Product Change Notice – I.G. Unit Spacer and Sealant

Product affected: 6400 series IG Vent Units.

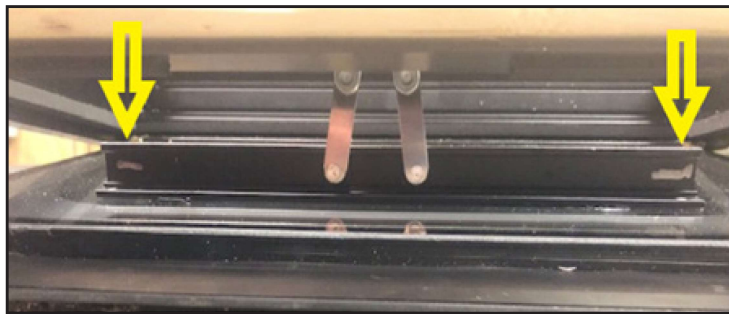
As part of our ongoing efforts to improve product performance and longevity, we will be making a running change from the current I.G. glass spacer and secondary seal to a glass spacer with a PIB primary seal on 6400 bonded vents. The combination of the new spacer and urethane creates a more robust assembly that offers additional strength and durability.

The photo below serves as an example how to quickly identify the new I.G. assembly by the silver paint lines on each end of the operator rail (see yellow arrows). This marking will be applied until January 1st, 2021. There will be no noticeable aesthetic changes to the parts. The change will take effect 30 days from the date of this notice.

- 1. Will a new part number be required?** No, there is no new part number.
- 2. Does the price change for the item?** No, there is no price change.
- 3. Is the new part wholly interchangeable with the previous version of the part?** Yes, the versions are interchangeable.
- 4. Does the customer need to replace inventory?** No, the change will be made on a running basis, starting 30 days from the date of this notice.
